Technical Service Information

THM 4L60-E TRANSMISSION OVERHEATING AND/OR CONVERTER DISCOLORED

Figure 1

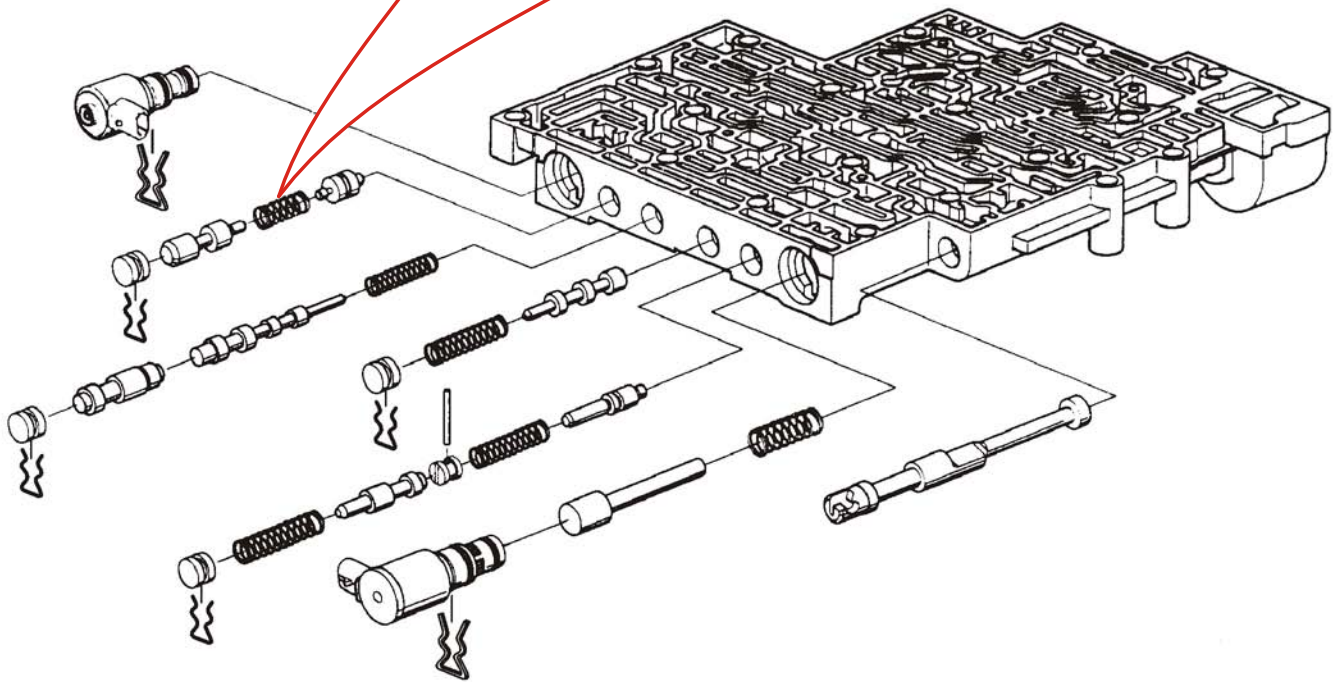
- COMPLAINT:** Before and/or after rebuild the torque converter is severely discolored from an overheating condition, and this sometimes happens on the road test, after installing a new torque converter.

- CAUSE:** The cause may be, no regulated apply oil available because of a TCC/PWM solenoid filled with debris that does not allow TCC Signal oil to stroke the TCC Regulator valve in the valve body. There are no codes stored, as the TCC/PWM Solenoid is still working electrically.

- CORRECTION:** To eliminate the possibility of this overheating condition happening to you or to your customer, we are recommending to replace the current spring between the valves in the TCC Regulator Valve line-up with a 700 inner pump slide spring, as shown in Figure 1. This will completely by-pass the TCC Regulator Valve, provide a more positive lock-up apply feel, and guarantee that you will always have apply oil available.

REPLACE THIS SPRING WITH AN INNER
PUMP SLIDE SPRING FROM THM 700-R4
OR THM 4L60-E TRANSMISSION
